Project Number: 2023-4439

**RE: FOOTE MINERAL SUPERFUND SITE GROUNDWATER & SURFACE WATER ANALYSIS REPORT
DATED JULY 13TH – RESPONSE TO EPA COMMENTS FROM SEPTEMBER 14TH 2023**

**Responses to EPA Comments
2023 Foote Mineral Superfund Site Monitoring Plan**

Attachment A – Analysis of Historical Lithium Results

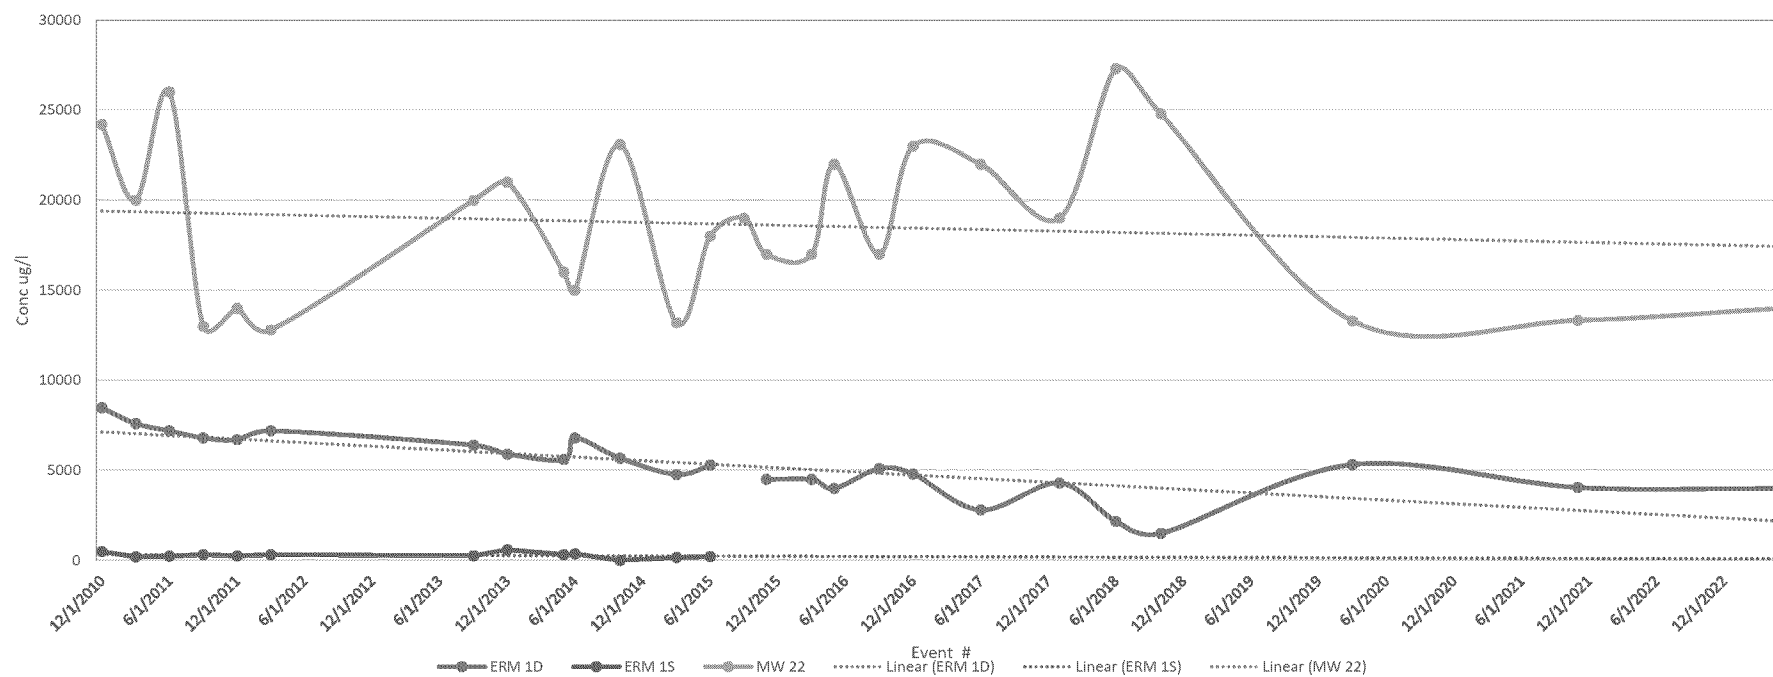
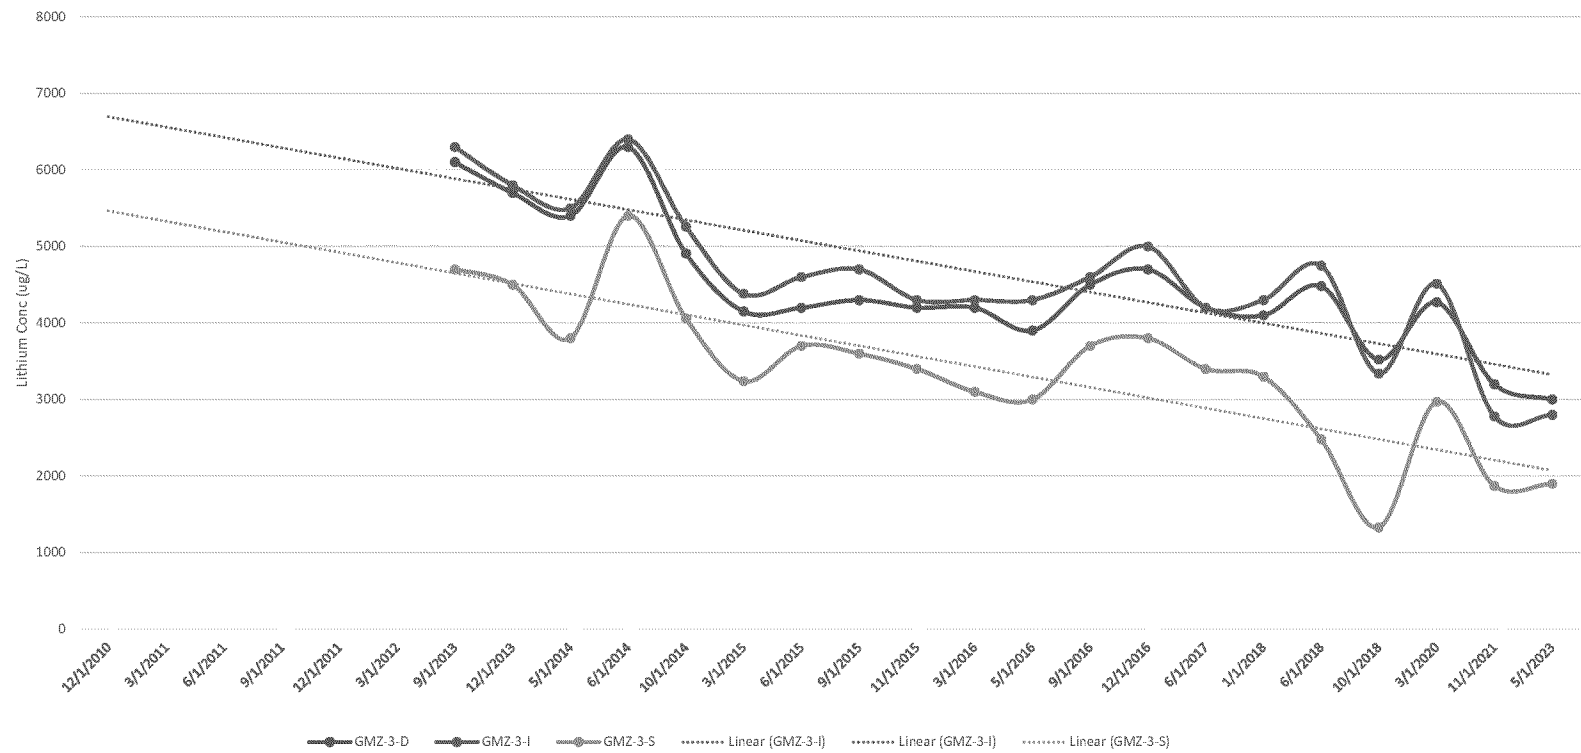
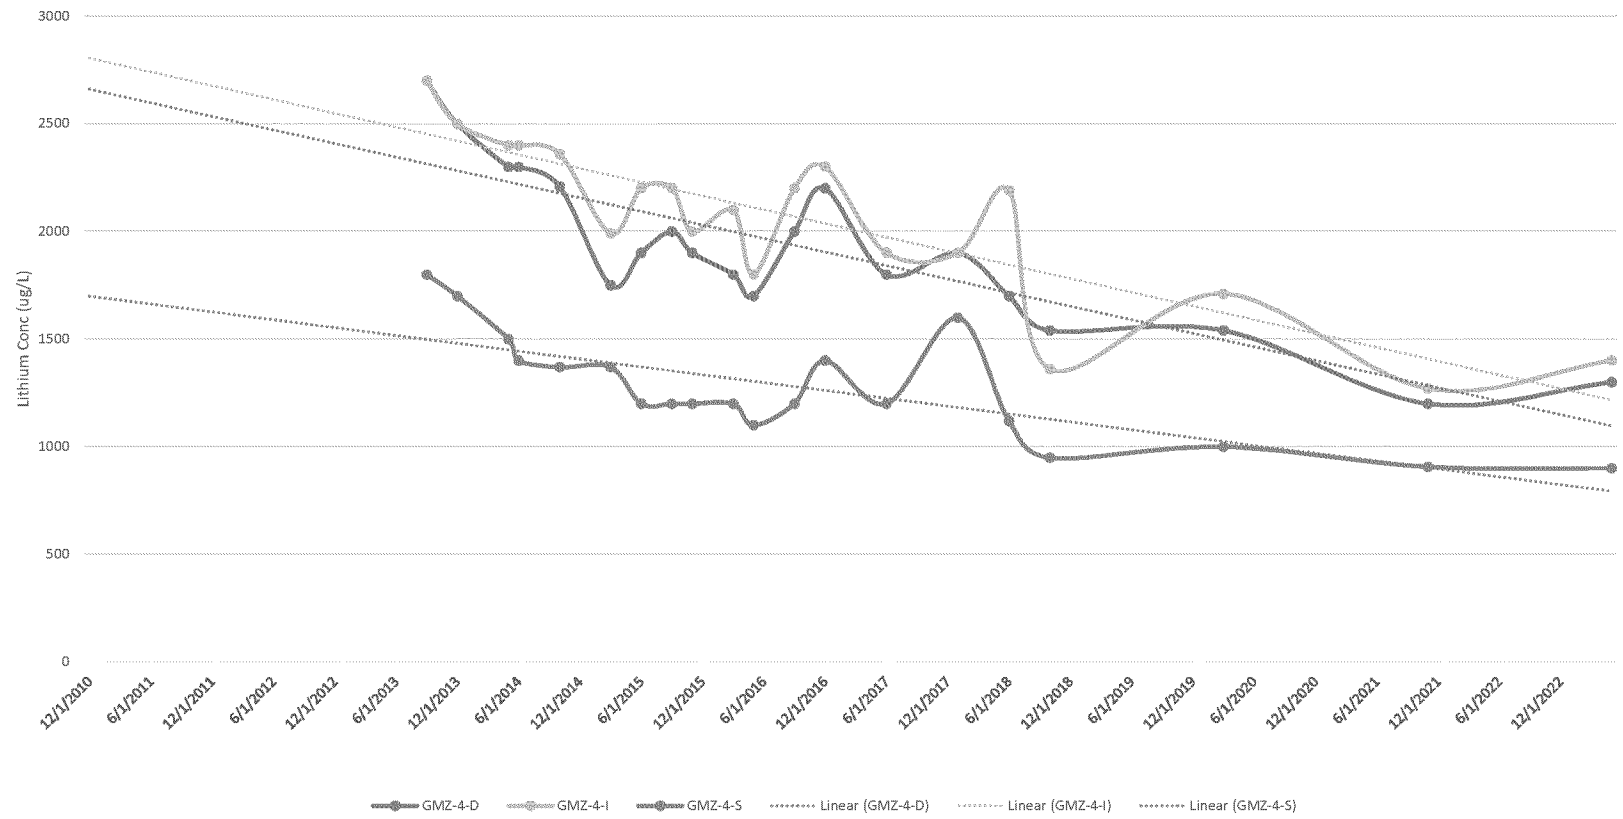
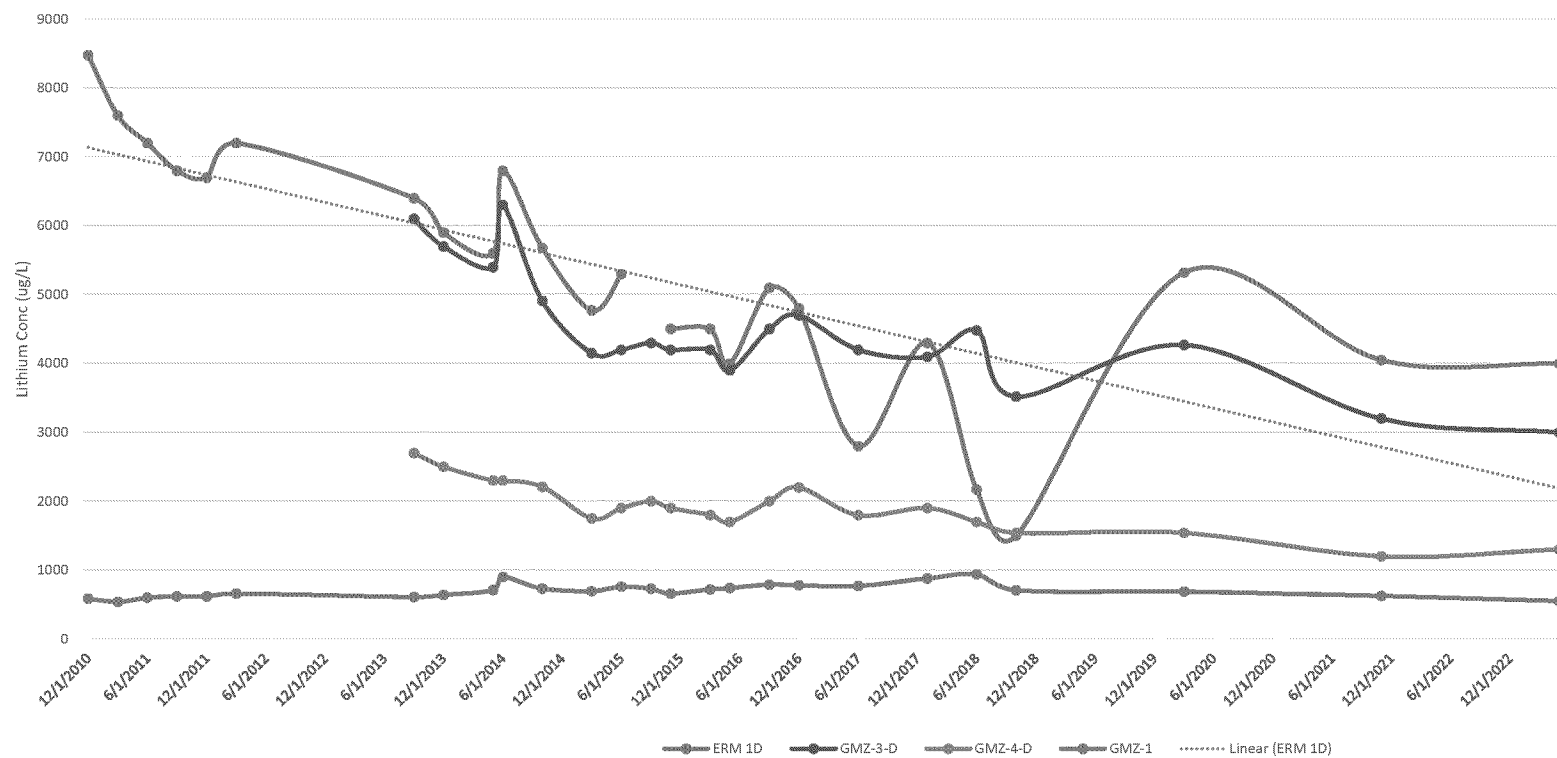
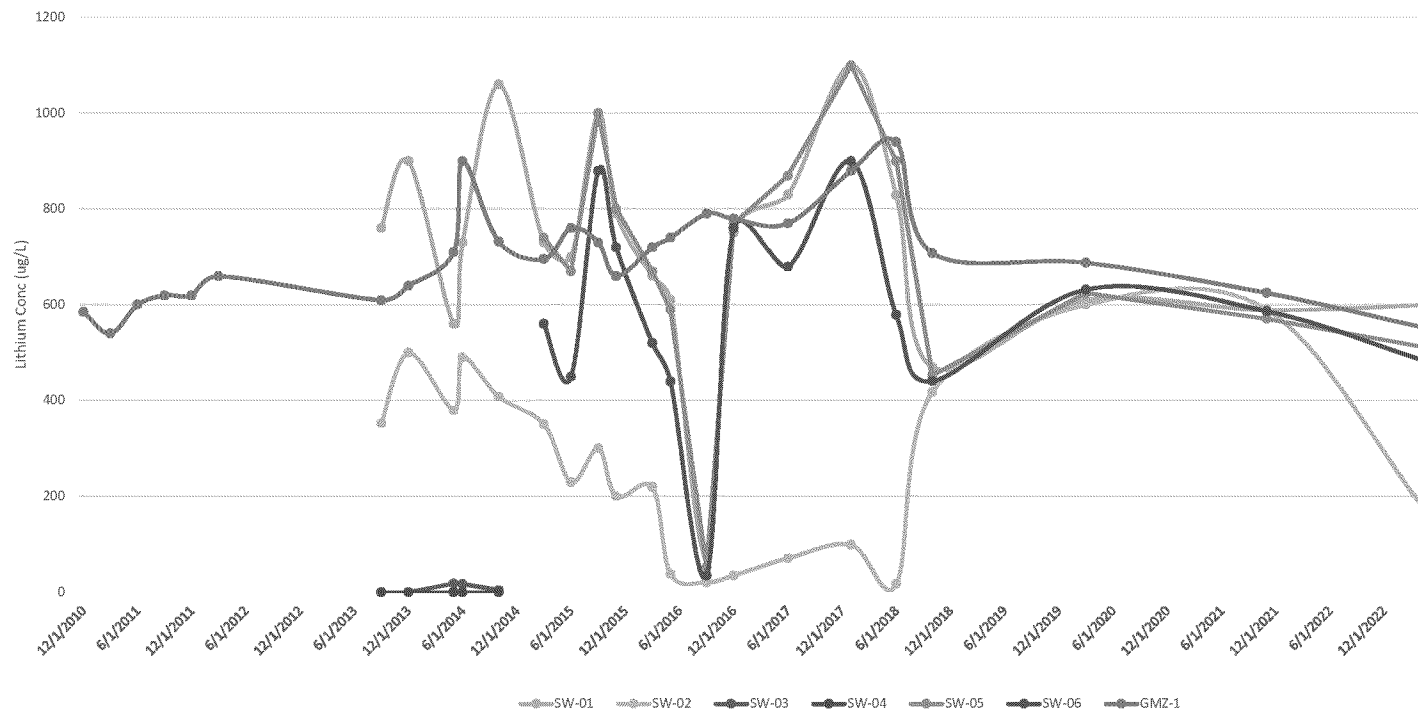
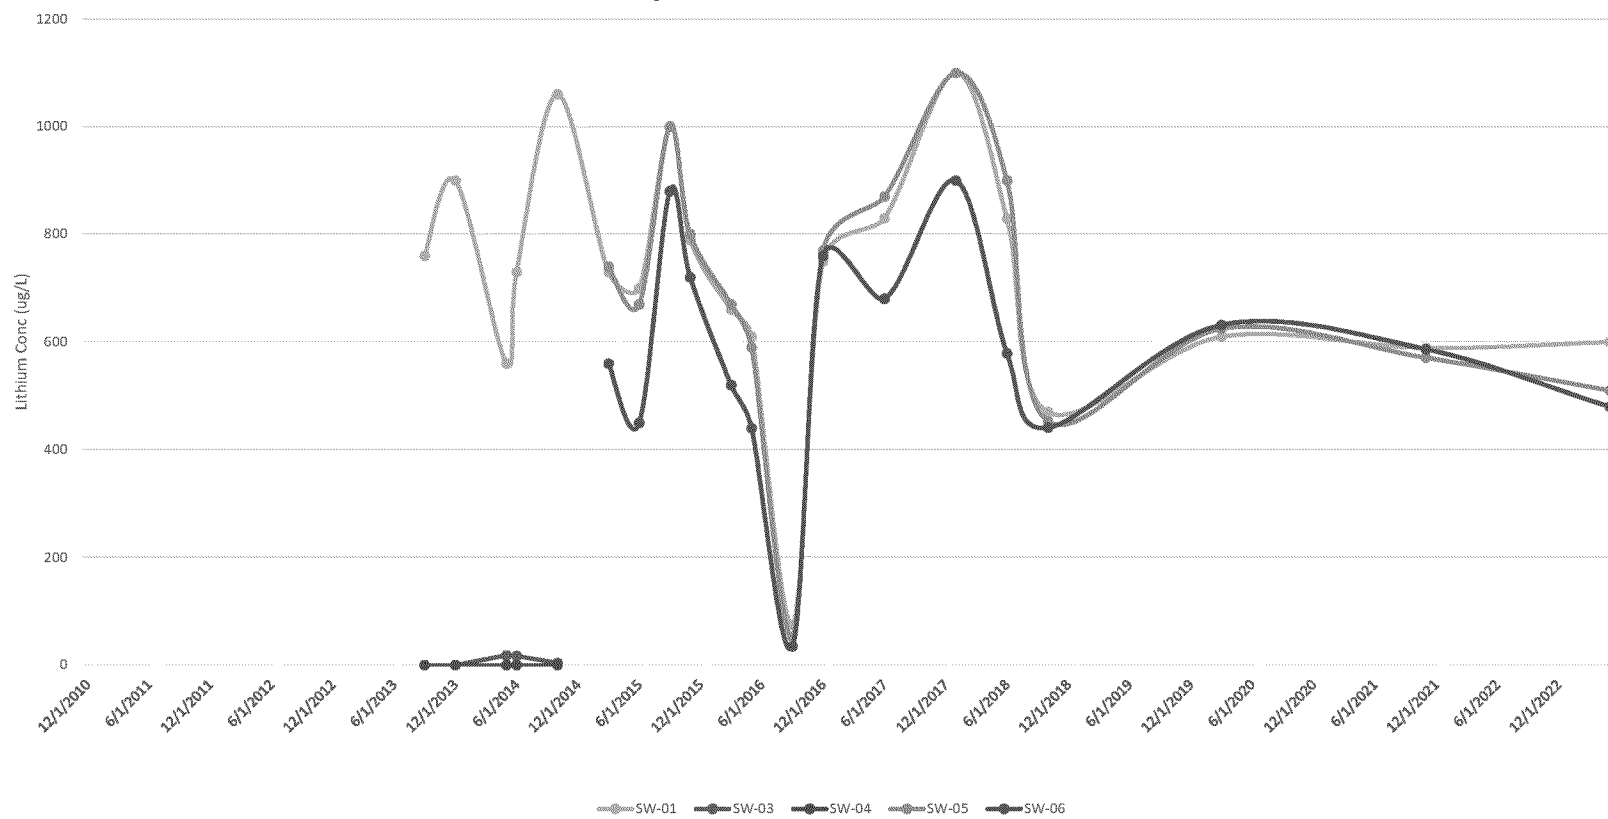
7. **Appendix A – Can Figures displaying contaminant concentrations please show not only what sampling event number on the X axis, but also when the sampling event occurred for context.**

The figures were presented and labeled in the same manner as the Figures in Attachment 3 of the Second Five Year review from which they were derived. Per your comment, the figures were updated and are provided as Attachment A.

Figure A-7
Comparison of SW-01 and GMZ-1 (~Colocated Samples)

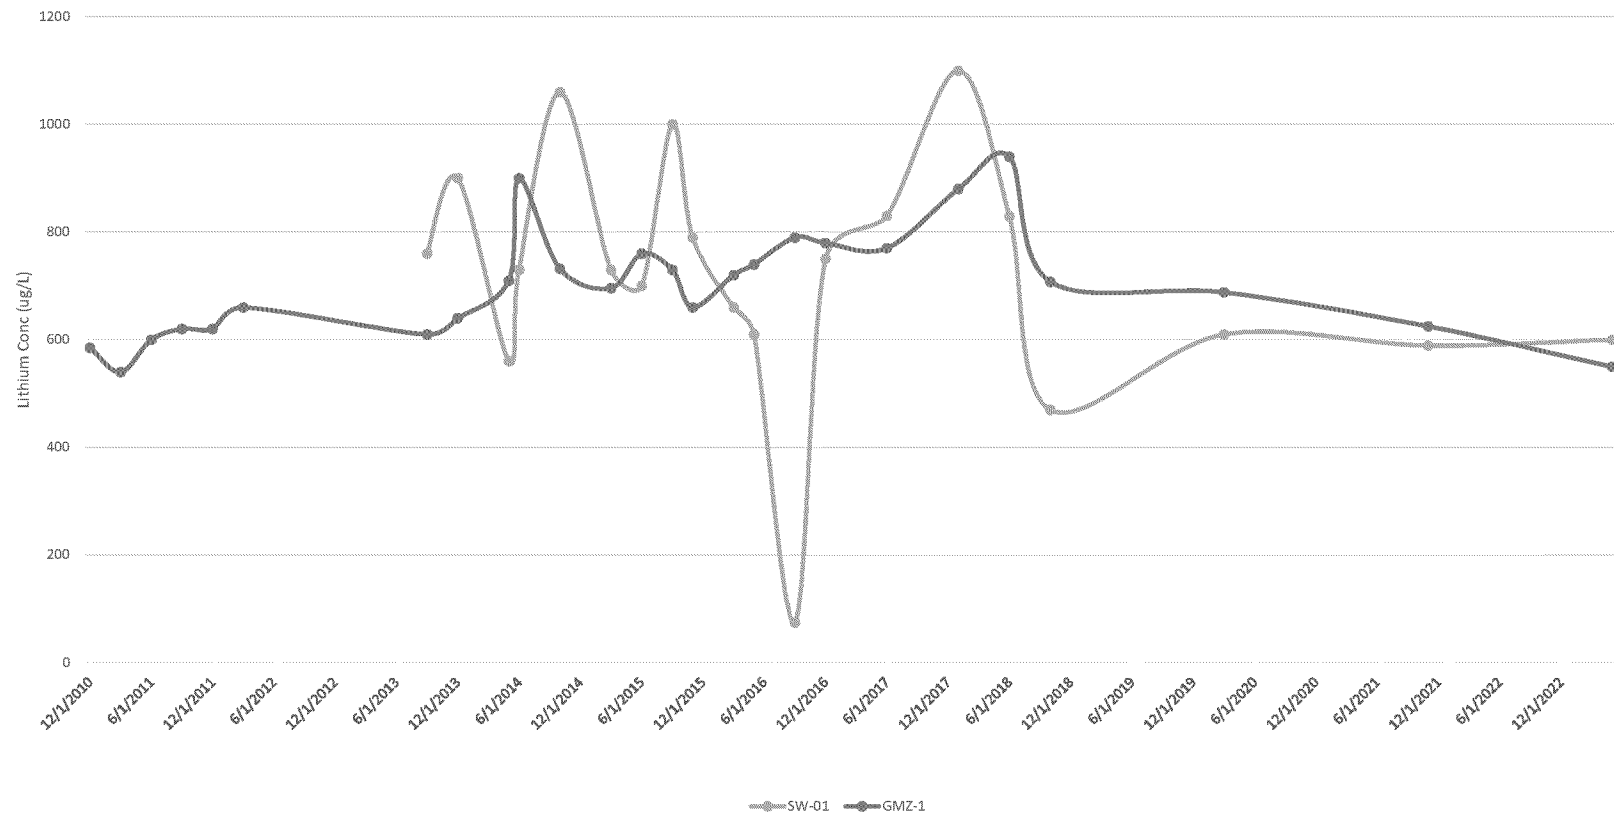
- 2. The currently available ecotox data indicates that concentrations of site contaminants, notably lithium, at downstream locations may be at levels that pose an unacceptable ecological risk. The downward trend of surface water contaminant levels noted in the Second Five-Year Review Report (FYR) no longer appears as significant since concentrations have rebounded from the levels preceding the FYR. Of the four surface water locations sampled, three have concentrations of lithium that may pose a risk to ecological receptors.**

At a minimum, the current surface water monitoring program should continue. Given the elevated concentrations of lithium at the furthest downstream sample station, it may be warranted to add a station further downstream. If a sustainable and notable downward trend does not become apparent, site-specific toxicity evaluations will be warranted.

“Lithium results from the furthest monitoring well, GMZ-1, which is a single deep well located approximately 8,400 feet from the quarry area, have been variable within the range from 610 µg/l to 940 µg/l [i.e., Montrose notes this is very similar to the stream concentrations described above]. The results suggest an apparent increasing contaminant trend which at this location could be an expression of the lag time associated with groundwater movement. As this monitoring point is over 8,000 feet distant from the quarry area, it is believed that the well is still showing the temporary increase in contamination due to the disturbance of the waste caused by the remedial activities conducted between 2007 and 2010; [emphasis added] the expected reduction in groundwater contamination as a result of stabilizing and capping the waste would not have had time to travel the distance to this well.”

This statement from the Second Five Year Review is supported by the data provided on Figure A-7, provided as Attachment A to this letter which seem to be “playing-out” in the manner described above, with the elevated concentrations which were measured in 2017/2018 being followed by a significant declining trend at GMZ-1. The specific measurements ranged from 940 in June of 2018, to 708 in October 2018, to 688 ug/l in March 2020, to 625 ug/l in November of 2021 and most recently 550 ug/l in the most recent sampling event. This is exactly the behavior anticipated in accordance with the Second Five Year Review statements. The same trend is observed with the surface water, which is represented by SW-01 of Figure A-7. Specifically, once the higher concentration lithium, associated with the remedial disturbance, passes through the system, the lithium concentrations decline. In fact, since 2018 there has been a 41% reduction in the concentration.
